PacifiCorp Geothermal Studies

Oregon Geothermal Working Group

September 15, 2011

Comments Received to Final Study

Geothermal \$/MWh Cost of Energy Comparisons

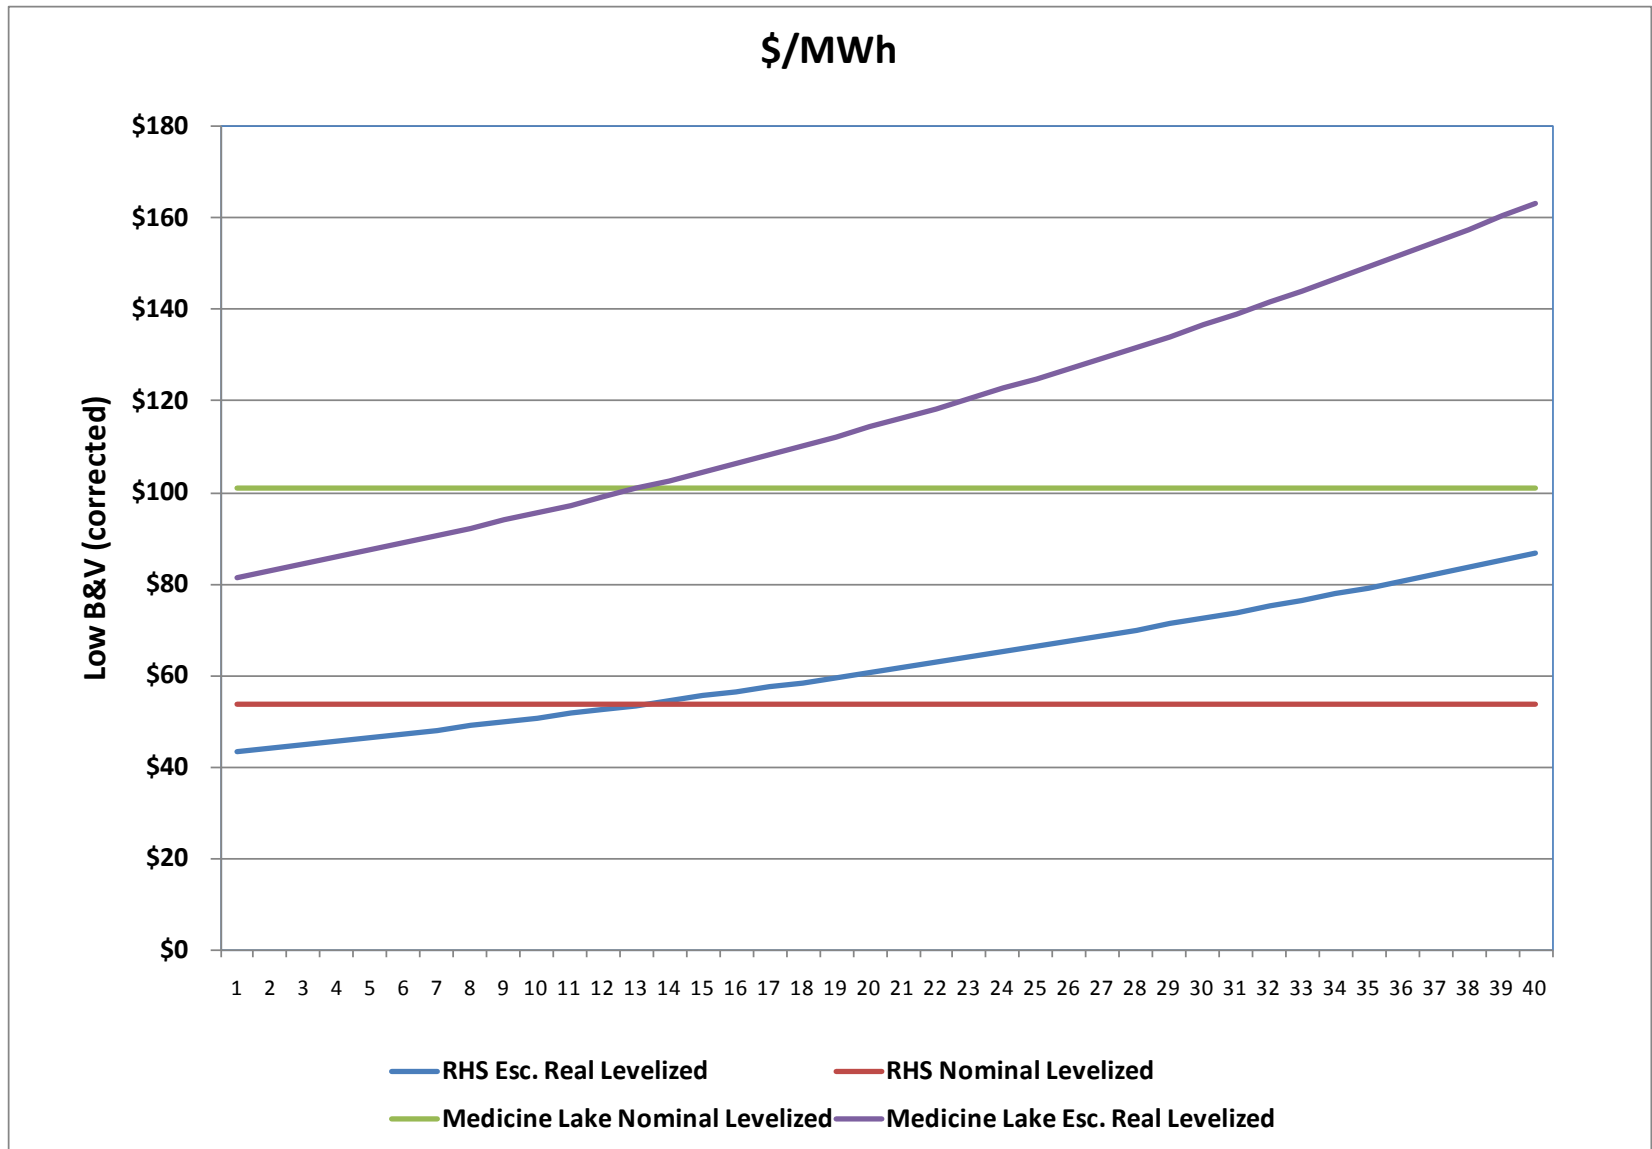
1. Expand list of non-commercial options (Appendix A) with additional information on development plans
2. The Company should proceed with the Blundell expansion
 - a. Model Blundell expansion in current IRP
 - b. Model other geothermal resources in current IRP
3. Compare the IRP LCOE methodology to the B&V LCOE methodology
4. Conduct a second, more in-depth geothermal resource study for the 2011 IRP Update to be available in March 2012

- Two types of levelized cost of electricity numbers:
 - 40 year nominal levelized cost of electricity
 - First year cost of electricity (IRP methodology)
- Recent review identified some issues with the B&V LCOE analysis (explained in the notes to the table)
 - Unlevered cash flows
 - 20 year Modified Accelerated Cost Recovery System (MACRS) depreciation

1. The B&V model had a formula error which resulted in the 20-year MACRS depreciation being excluded.
2. The B&V model calculated an equivalent COE by solving for a required equity return. This equity cash flow approach results in disproportionately more debt capitalization throughout the analysis period than is consistent with the typical debt and equity weighting of a regulated utility (47.43% and 52.57%, respectively).
3. The first year real levelized COE derived with the IRP methodology provides results very similar to the COE derived with the corrected B&V analysis model.
